**From: Andrew Llowarch**  
**Sent: 23 December 2024 15:12**  
**To: Planning; Ewan Campbell**  
**Cc: Alex Bushell**  
**Subject: OBJECTION: Application Number2024/5410/P - fao Ewan Campbell**

My family and I live at number 74 Camden Mews, immediately adjacent to the proposed development at 72 Camden Mews.

**ASSESSMENT OF DAYLIGHT & SUNLIGHT: 74CM REAR**

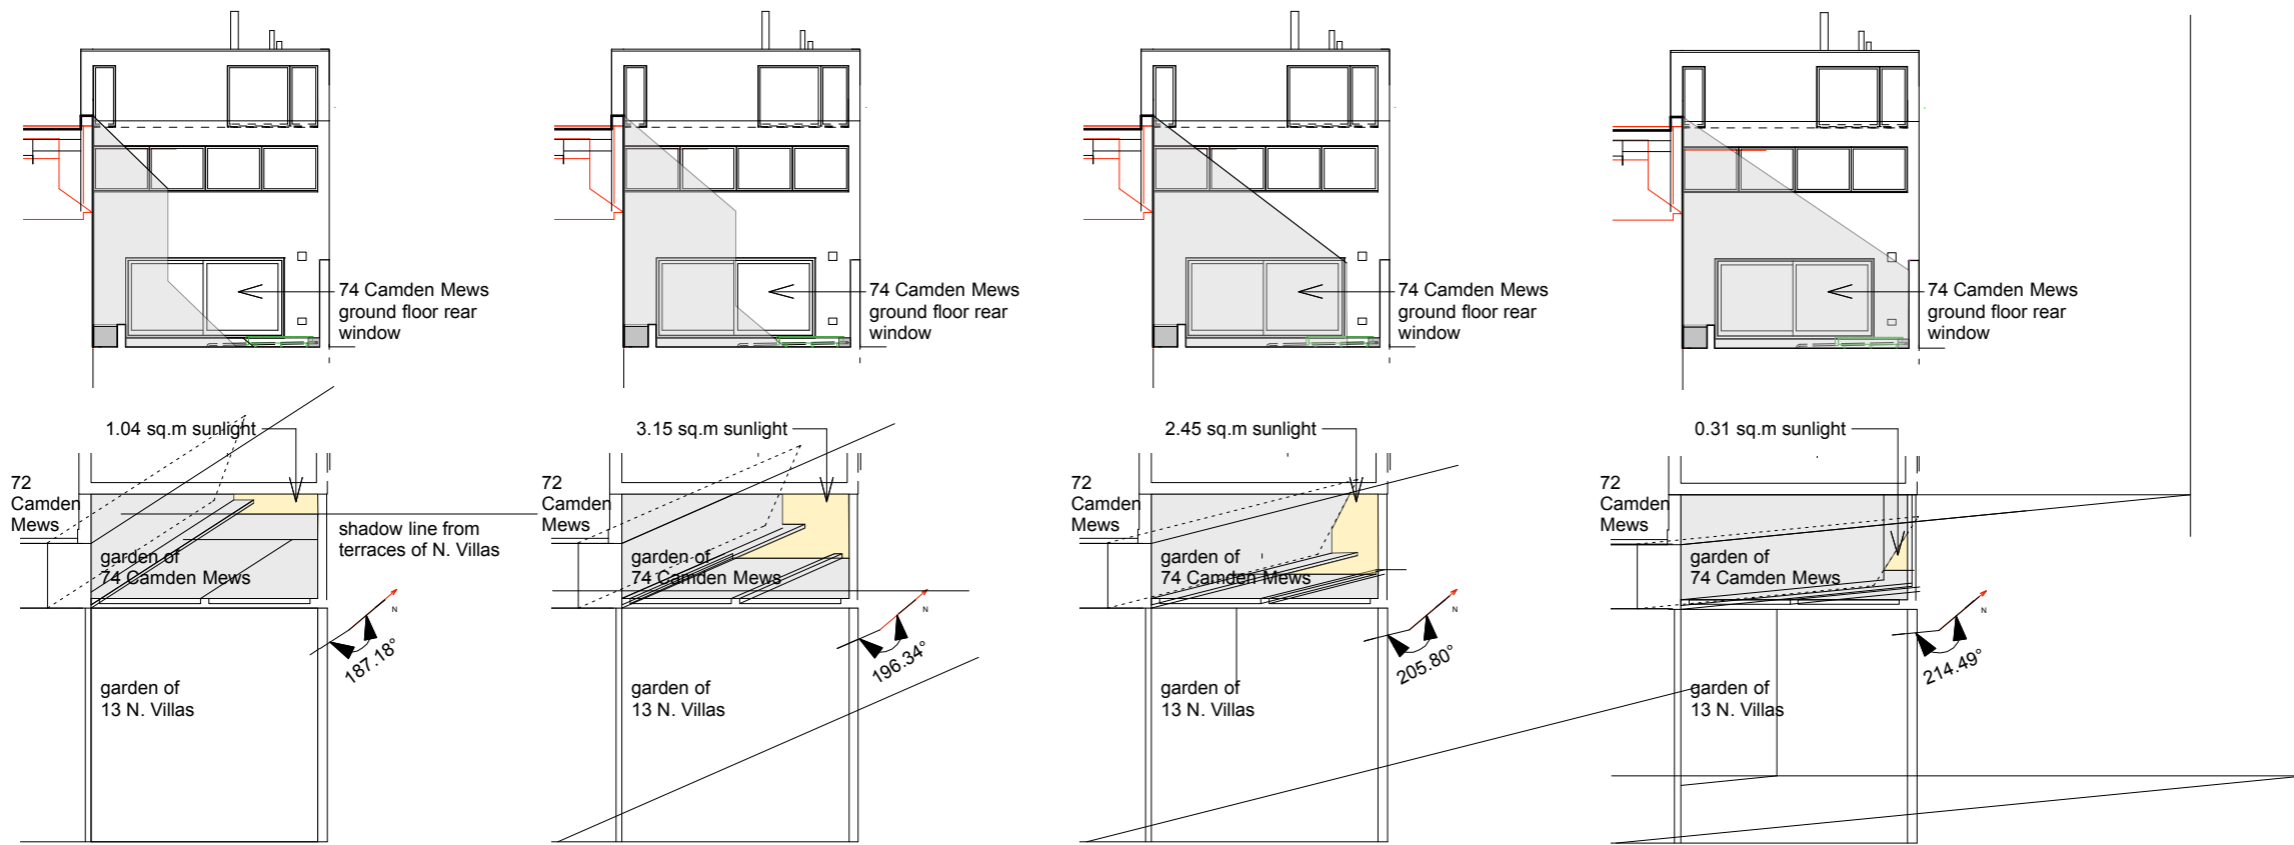
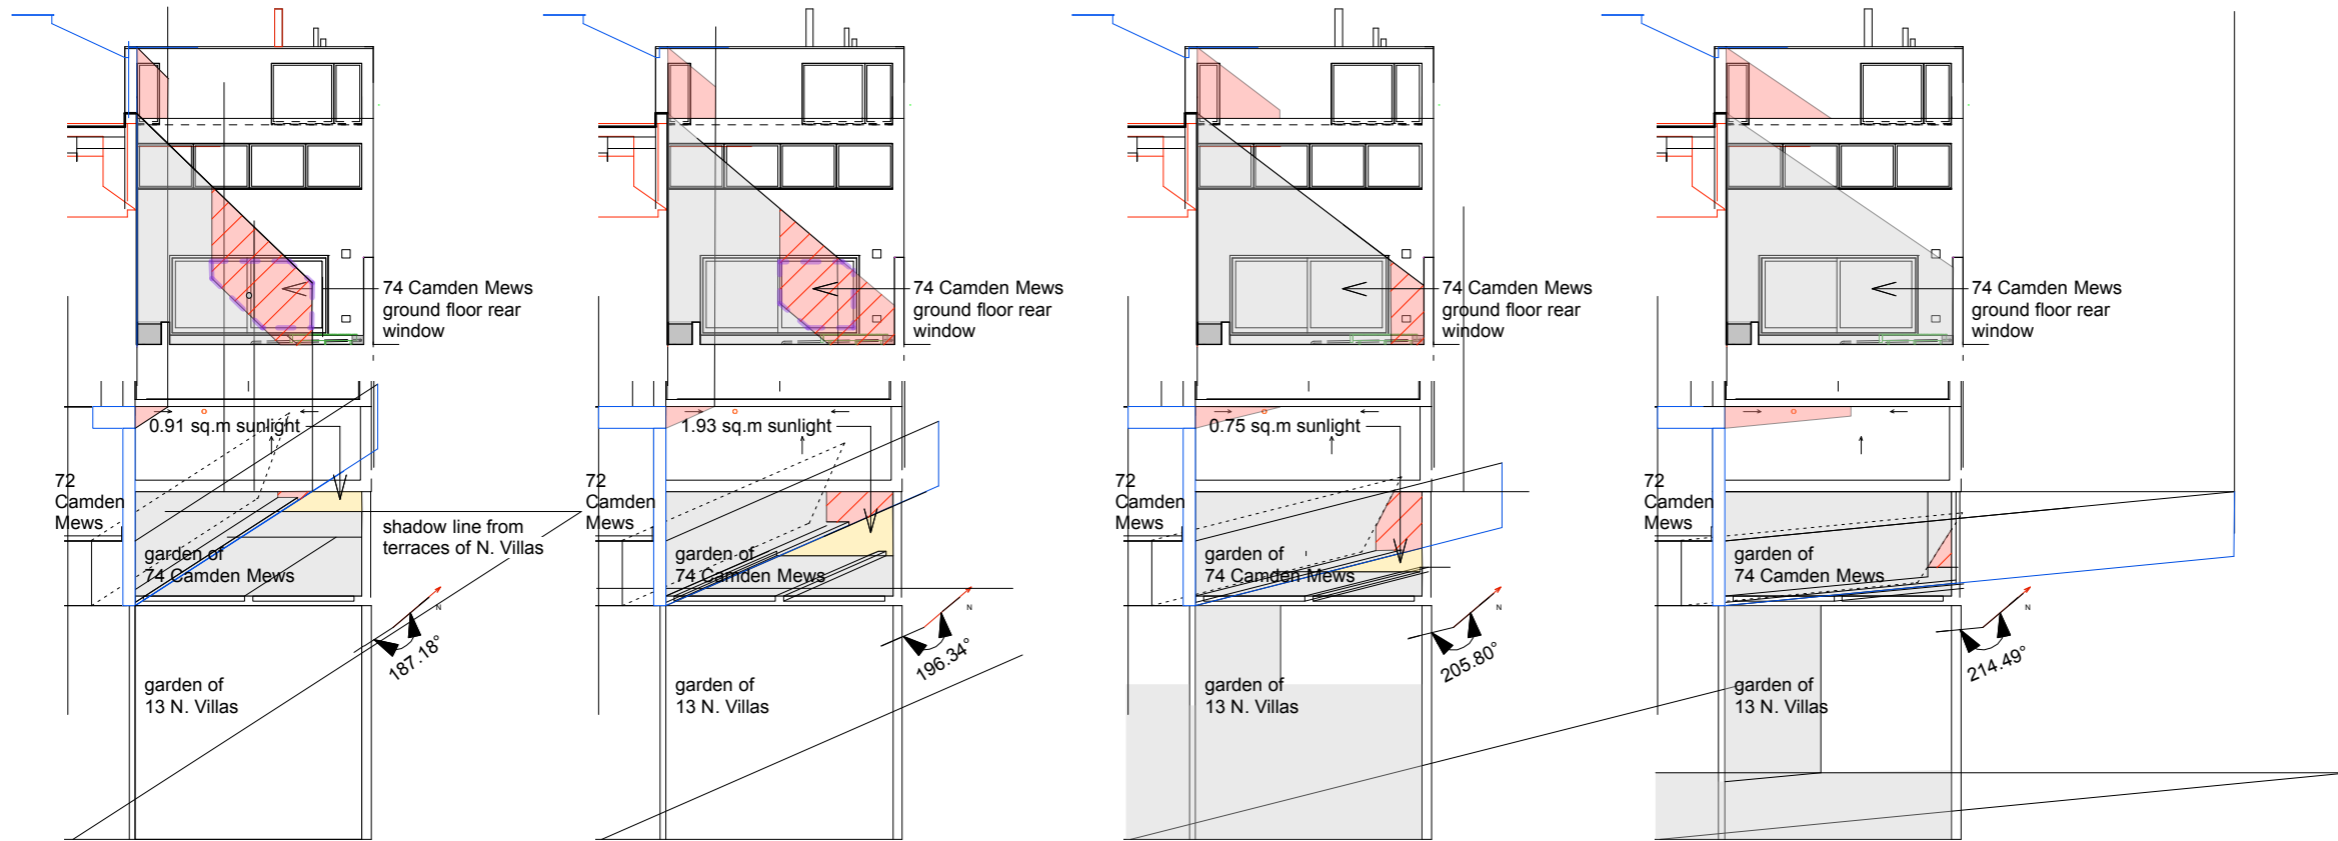
**As the application does not include a daylight and sunlight assessment, I have carried out my own studies represented by the attached scale drawing 241212\_SK01 that contains a number of shadow & sunlight diagrams demonstrating the additional overshadowing that would be caused by the proposed development on 21st March (according with BRE guidance).**

**These diagrams show that increased overshadowing from the proposed development reduces sunlight to the rear garden by almost 50% on 21st March which we believe to be in excess of the BRE guidance.**

**In addition, our ground floor rear window is within 90 degrees of due south and therefore meets the criteria set by the BRE guidance for an assessment of direct sunlight to windows.**

**The attached scale drawing 241212\_SK01 demonstrates that the increased overshadowing from the proposed development would cause loss of direct sunlight to this window on 21st March with a significant reduction to approximately only 15% of existing levels - this is a very large and significant reduction of sunlight.**

**The attached scale drawings demonstrate that the increased massing of the proposed first floor rear extension to 72 Camden Mews would cause increased and significant overshadowing and loss of sunlight to the garden and window (and by extension to the living spaces inside Camden Mews). This would cause unacceptable harm to amenity in excess of the BRE guidance, and on this basis the proposals should be refused.**

241212\_SK02

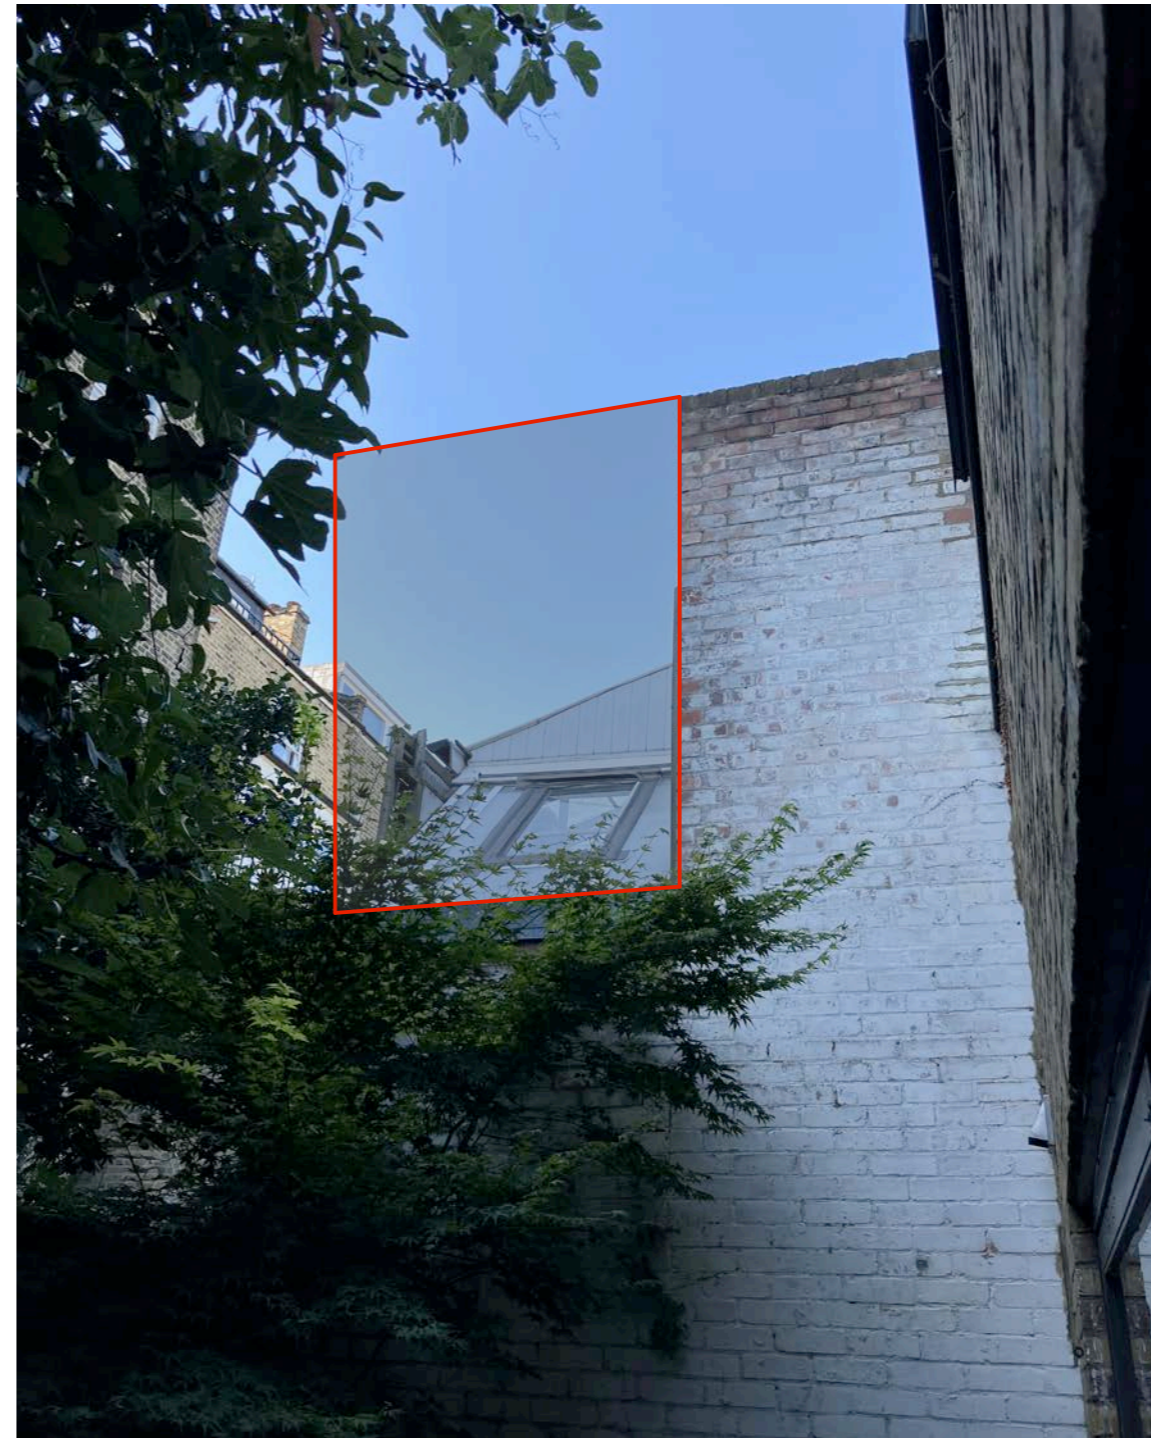
This proposed increase in massing as viewed from our home is represented by attached sketch drawing 241212\_SK02.

**The increased massing associated with the proposed rear extension would have a negative impact on outlook by significantly increasing the degree of enclosure of this space and blocking off a significant part of the sky, resulting in an overbearing and dominating effect that would be detrimental to the enjoyment of our property. See attached drawing 241212\_SK02. We believe this to be in contravention of the 2021 Camden Planning Guidance SPD on Amenity, sections 2, 2.13 & 2.14.**

— REPRESENTS MASSING OF  
PROPOSED REAR ADDITIONS TO 72 CAMDEN MEWS  
TO DEMONSTRATE NEGATIVE IMPACT ON OUTLOOK
